REV.  
D

AS3411™

BOLT, TEE HEAD - AMS5662, CHAMFERED, .3125-24 UNJF-3A (STRESS RUPTURE RESISTANT)

FIGURE 1

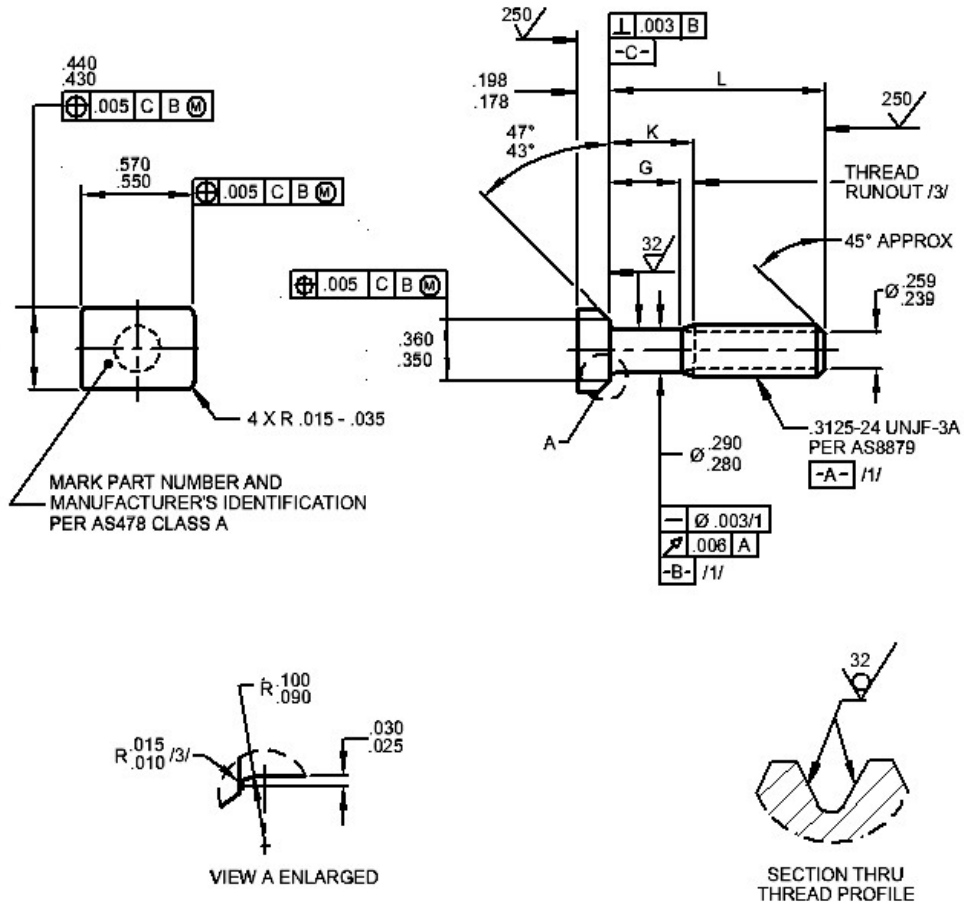
AS3411-56 DIMENSION L CORRECTED TO 5.490-5.510, POSITIONAL TOLERANCES BROUGHT INTO LINE WITH AS1132.
